**Product Change Notification / MFOL-04PKQY369**

CCB 4630.002 Final Notice: Qualification of STA as an additional assembly site for USB3340-EZK, USB3340-EZK-TR, USB3370B-EZK and USB3370B-EZK-TR catalog part numbers (CPN) available in 32L VQFN (5x5x0.9mm) package.

**CCB 4630.002**  
**Pre and Post Change Summary**  
**PCN# MFOL-04PKQY369**

ASE

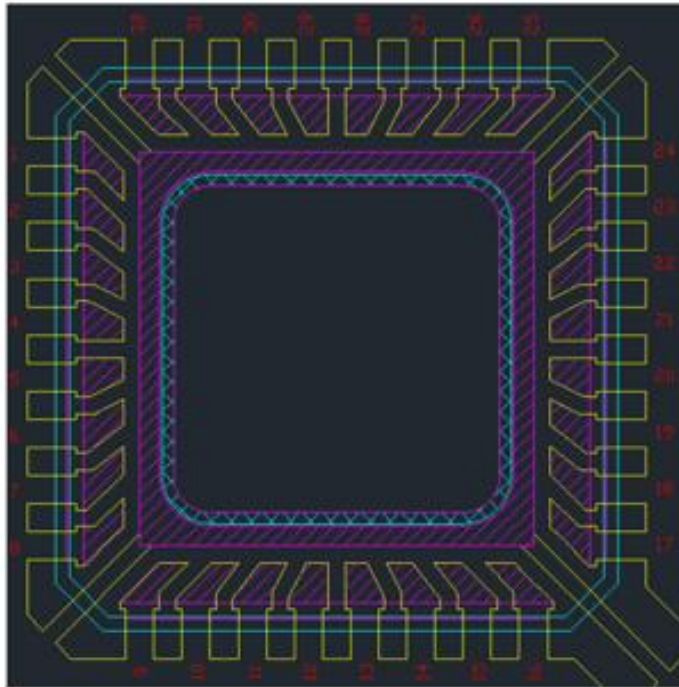
# Lead Frame Comparison

Lead frame  
material

C194

STA

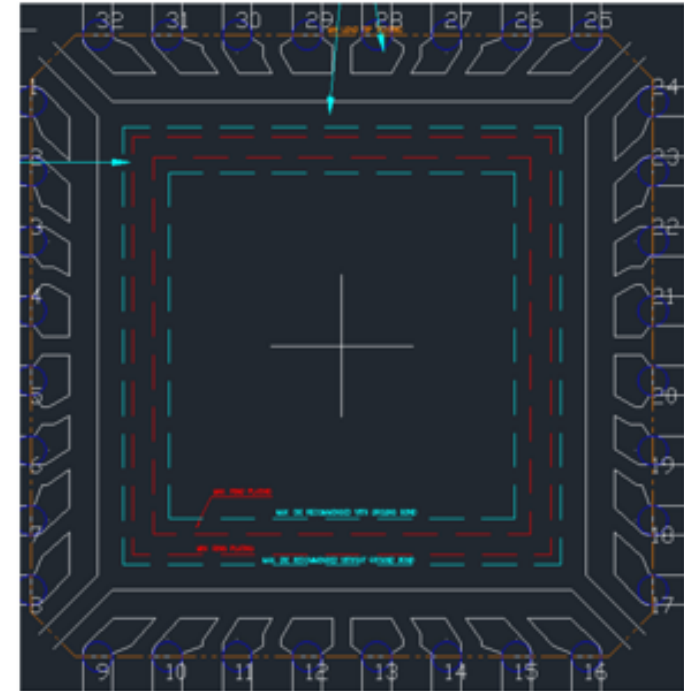
Lead frame  
material

C194
